**STAFF REPORT
WEST ALLIS PLAN COMMISSION
Wednesday, October 25, 2023
6:00 PM**

5. Site, Landscaping, and Architectural Design Review for Pan-Asia Supermarket, a proposed General Retail use, at 6900 W. Greenfield Ave. (Tax Key No. 439-0001-007)

The numbered items below are staff comments shared with the applicant upon review of the original plan submittal. The applicant's design team has revised plans to accommodate staff's recommendations. A comparison of the initial and most recent plan submittals is provided for Plan Commission review. After reviewing the revised plans, items 1-3 are satisfied, and items 4-5 were offered to applicant for consideration but not required.

1 SITE PLAN
 1" = 30'-0"

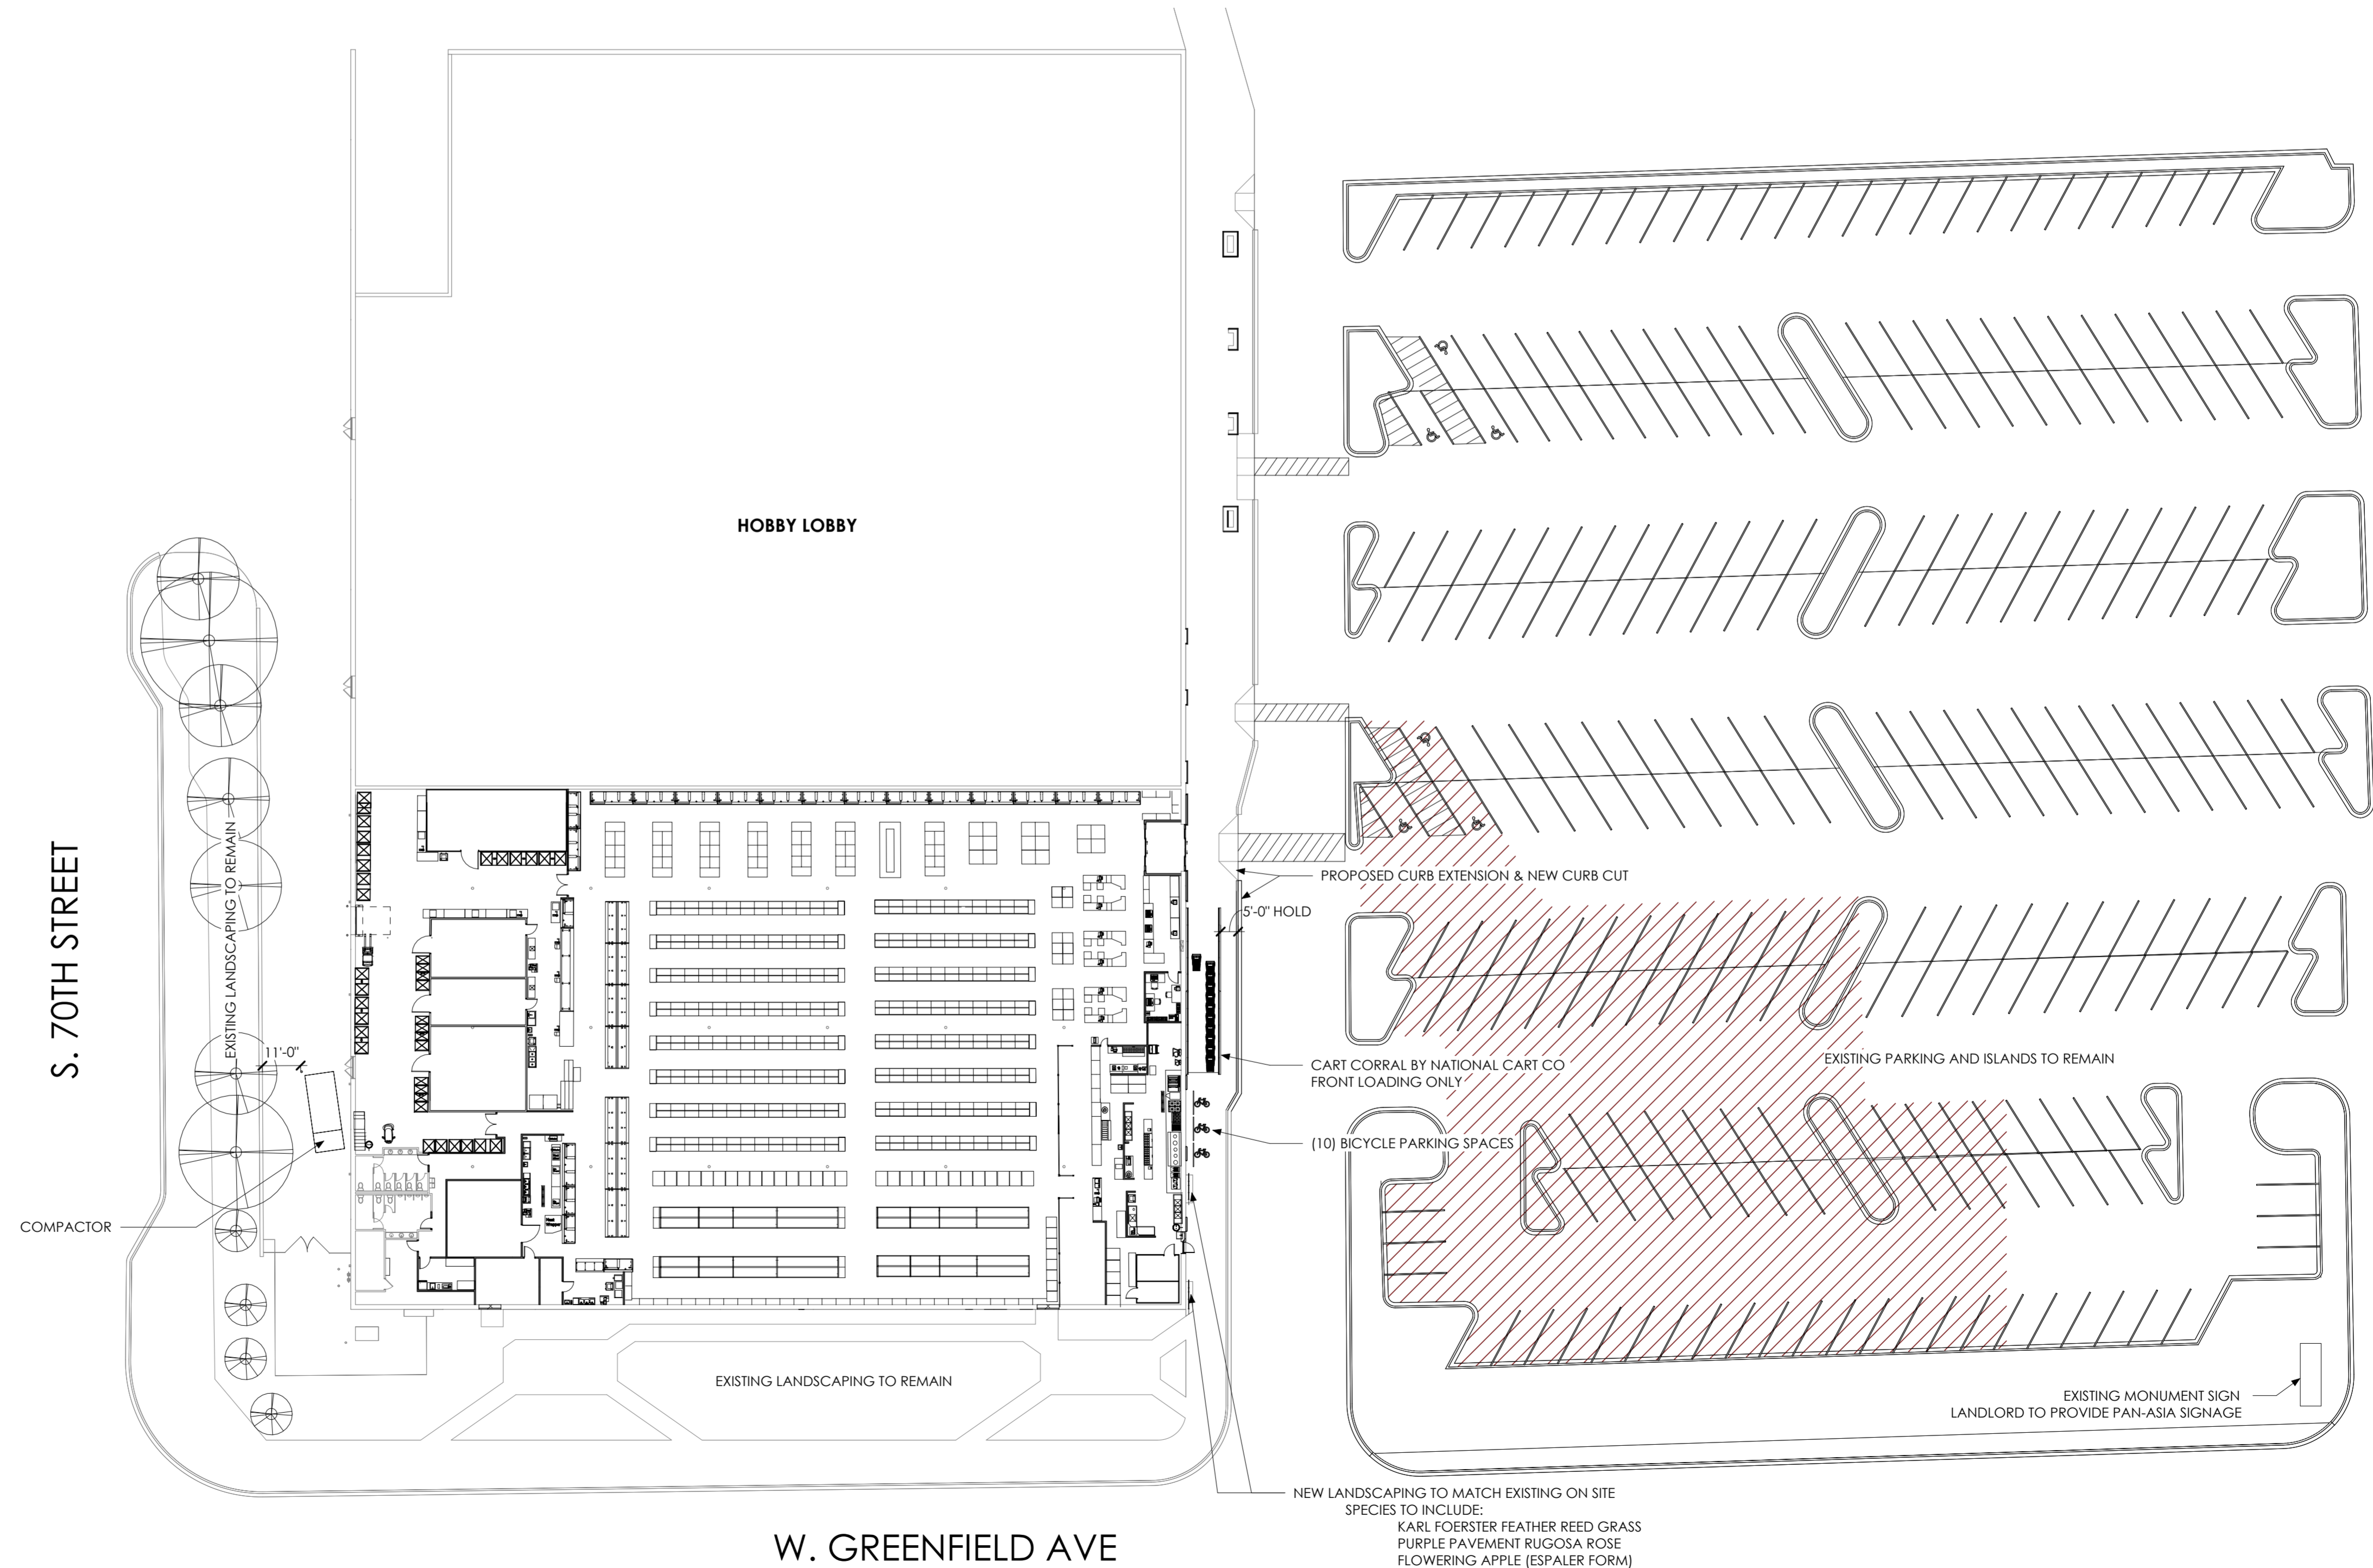
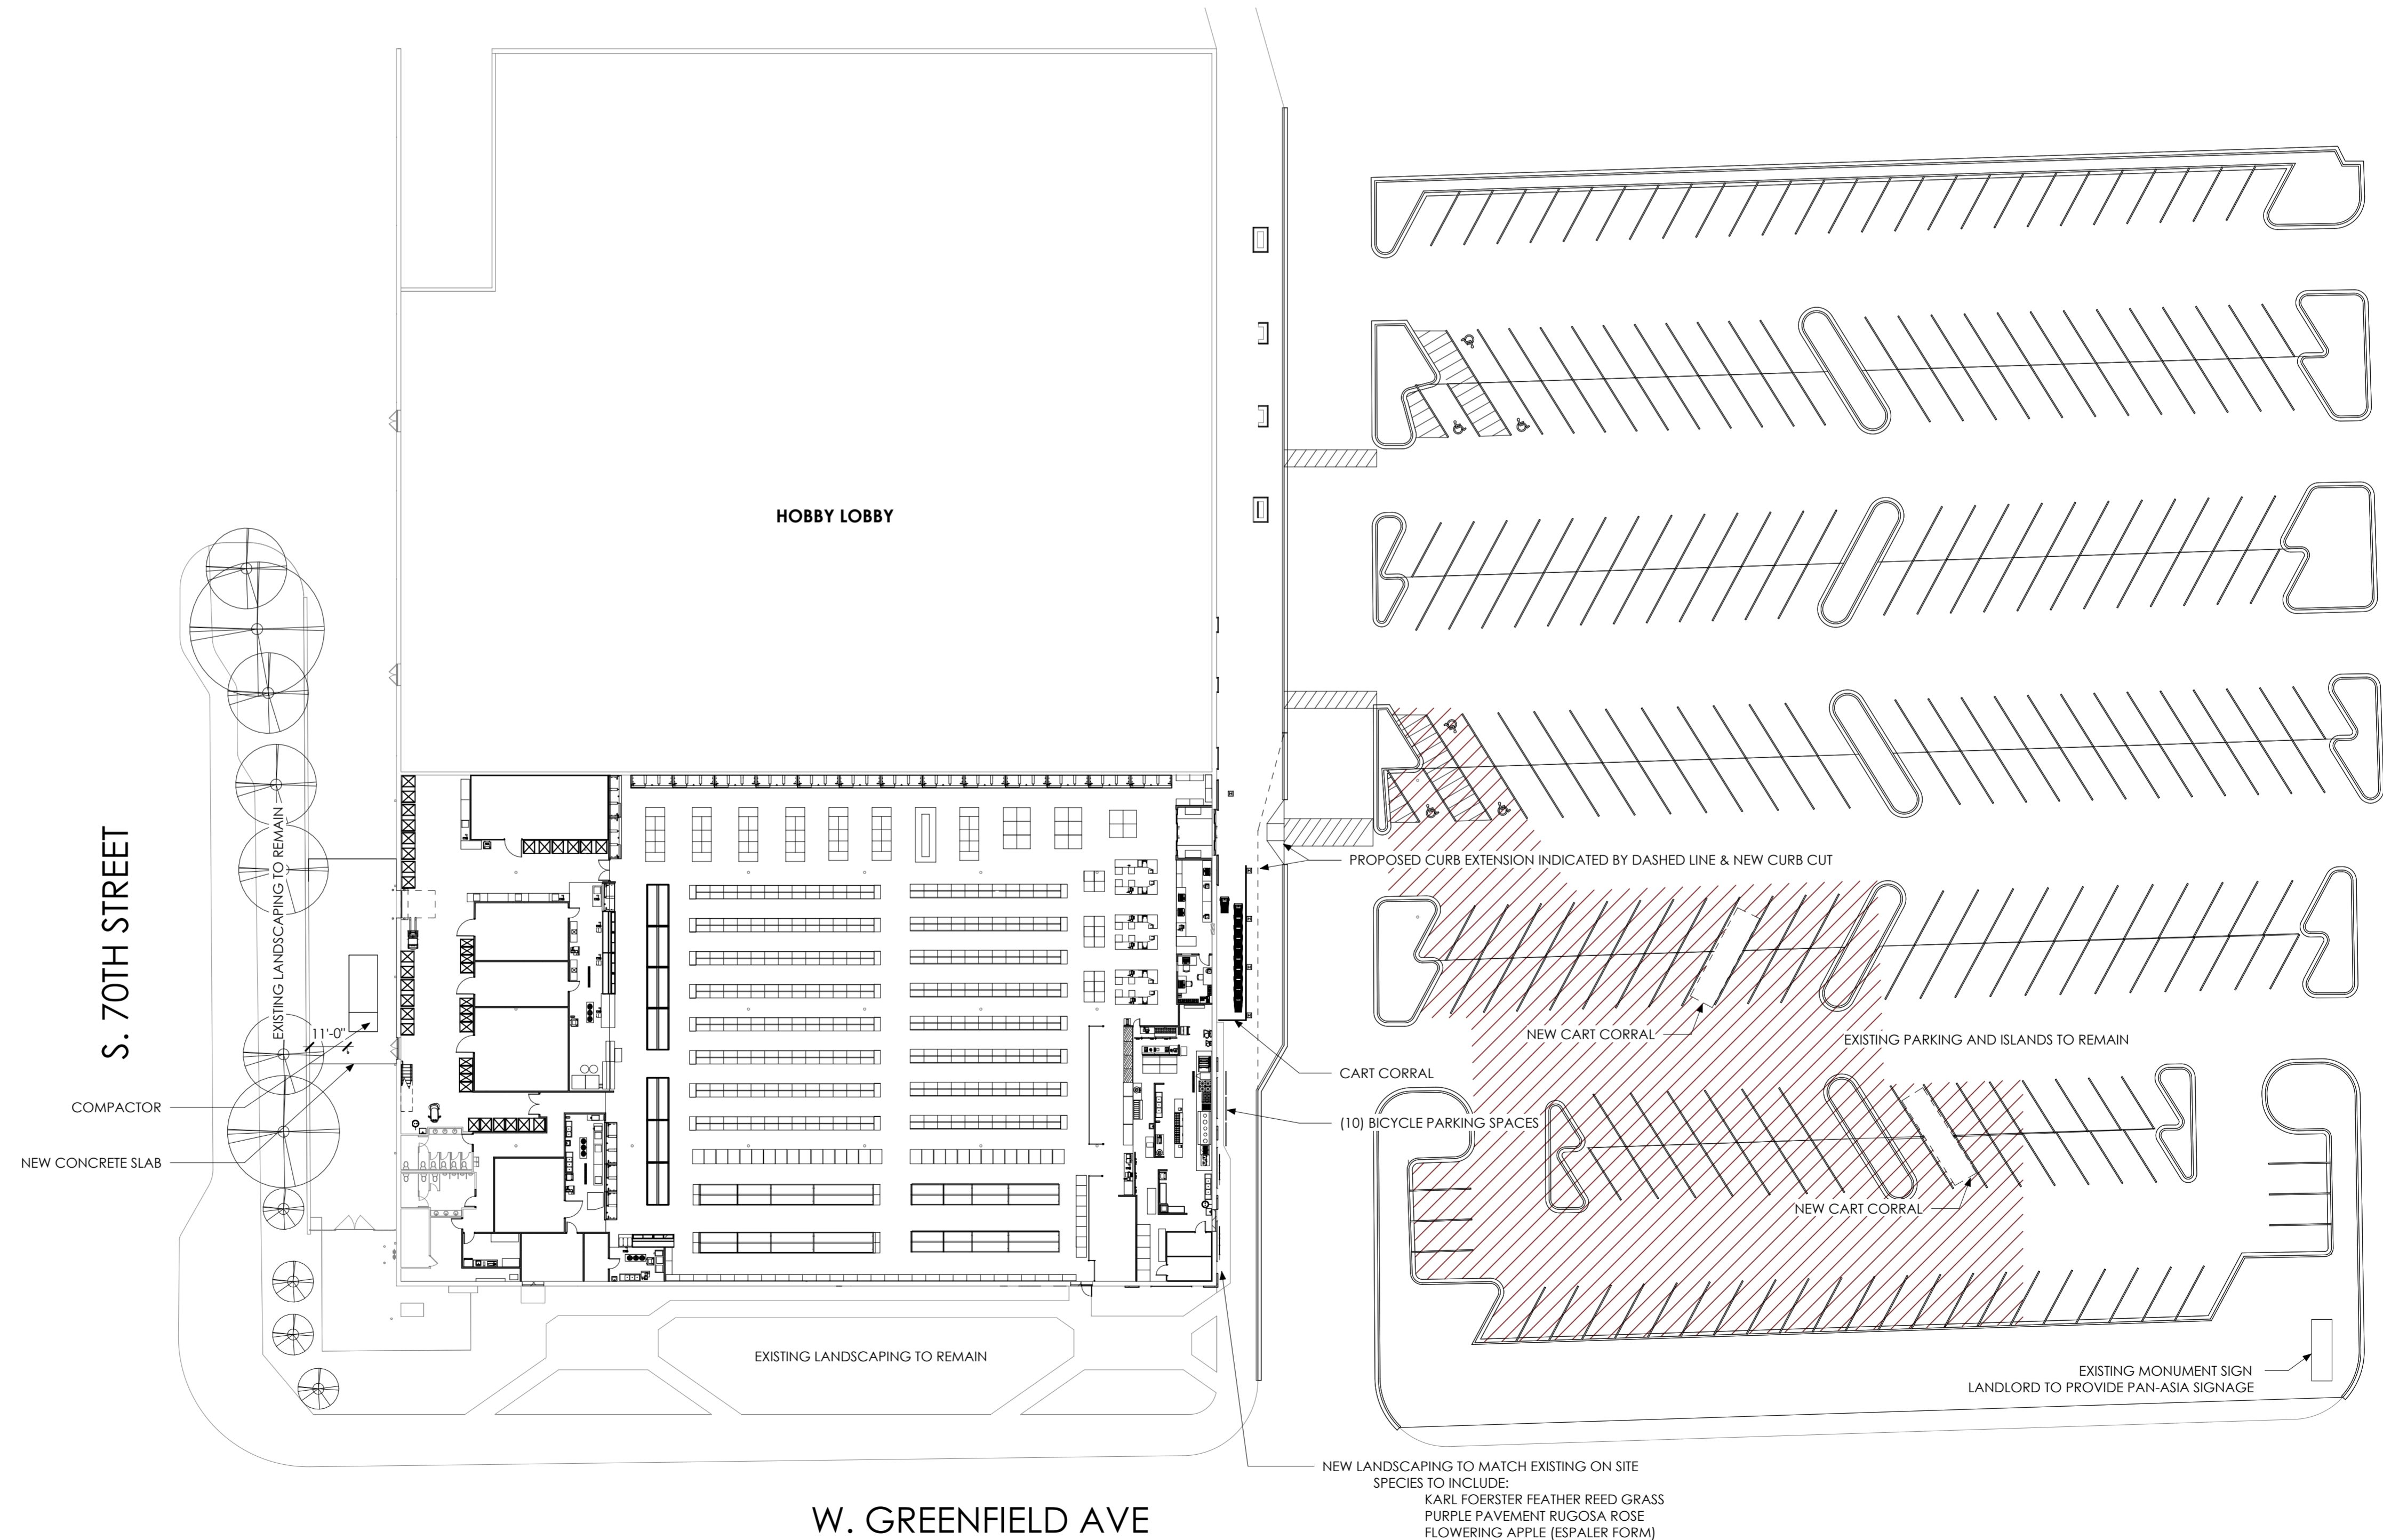
1. Recommend curb extension of storefront pedestrian walkway consistent with Hobby Lobby.
2. Will the parking lot feature a cart corral? Trying to avoid carts scattered about everywhere (details needed)?

3. Bicycle parking – The proposed store is in compliance with our zoning code which requires bicycle racks and accommodation for 10 spaces per table [19.44\(3\)\(a\)](#) and ii of the zoning code. [Sec 19.16](#) provides definition of bicycle parking.

4. Any consideration toward utilizing the [existing plaza area](#) along W. Greenfield Ave. for outdoor seating? There are some existing benches that customers could use for carry-out, but the proximity of the existing outdoor plaza and that of the proposed café offers some nice potential connectivity and thereby enhancing/creating place along the street. To this end one of the existing openings (proposed to be infilled) could be used for additional ingress/egress between the cafe - outdoor area.

PROPOSED CURB EXTENSION INDICATED BY DASHED LINE & NEW CURB CUT

NEW CART CORRAL

(10) BICYCLE PARKING SPACES
